Access Compliance Report

Public Rights-of-Way

(Curb Ramps)

Intersection ID: 44950	Main Street: WEAVERS_GLENN_PL	Cross Street: OLDCORN_LN	Location:	E
ADA ID: D68A8543E3E7	Ramp Type: PerpDiag	Initial Pass/Fail: Fail	Overall Compliance: No	Severity Score: 0
Codes/Mitigation Info/Possible Solution		Field Measurements/Component Compliance

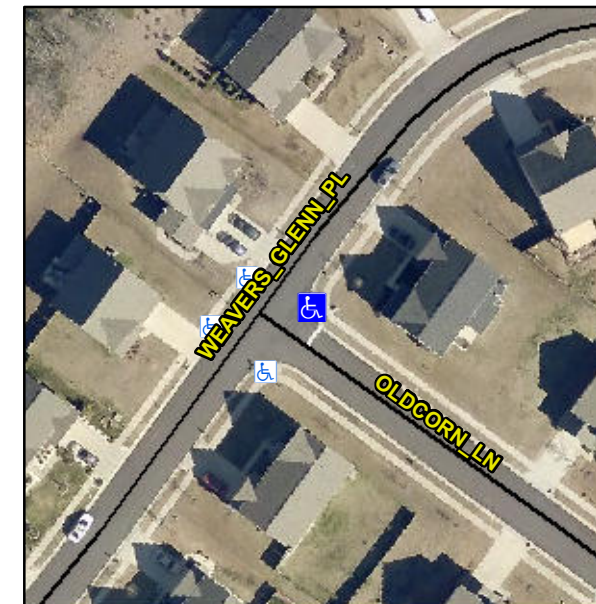
Compliance	Description	Data	Compliance	Description	Data
N/A	Ramp Length (in)	46.0	Yes	Ramp Slope (%)	5.6
Yes	Ramp Width (in)	48.0	Yes	Ramp XSlope (%)	1.1
N/A	Flare Type LT	N/A	N/A	Flare Type RT	N/A
N/A	Flare Slope LT (%)	N/A	N/A	Flare Slope RT (%)	N/A
N/A	Flare Traversable LT?	N/A	N/A	Flare Traversable RT?	N/A
N/A	Landing Length (in)	N/A	N/A	DWS Provided?	N/A
N/A	Landing Width (in)	N/A	N/A	DWS Contrast?	N/A
N/A	Landing Slope (%)	N/A	N/A	DWS Length (in)	N/A
N/A	Landing X Slope (%)	N/A	N/A	DWS Full Width?	N/A
N/A	Landing Curb? (Y/N)	N/A	N/A	DWS Offset (in)	N/A
N/A	Shared Landing?	N/A			
N/A	Gutter Ponding?	N/A	N/A	Gutter Slope (%)	N/A
N/A	Gutter Lip Ht (in)	N/A	N/A	Gutter X Slope (%)	N/A
N/A	Painted X Walk1?	No	N/A	Painted X Walk2?	No
	X Walk 1 Direction	To NW		X Walk 2 Direction	To SW
N/A	X Walk 1 Width (in)	N/A	N/A	X Walk 2 Width (in)	N/A
	X Walk 1 Slope (%)	5.7		X Walk 2 Slope (%)	0.2
	X Walk 1 X Slope (%)	1.2		X Walk 2 X Slope (%)	4.2

N/A	Ramp inside XWalk1?	N/A	N/A	Ramp inside XWalk2?	N/A
	Road Slope (%)	9.8	N/A	Clear Space?	N/A
	Road X Slope (%)	4.0	N/A	Clear Space to XWalk (in)	N/A
N/A	Any Obstructions?	N/A	N/A	Storm Grate/Utility Hazard?	N/A
	Obstruction Type			Storm Grate/Utility Type	
		N/A			N/A
			Yes	Surface Condition? (G/P)	Good

Remove & Replace Curb Ramp With Two New Directional Ramps or Equivalent.
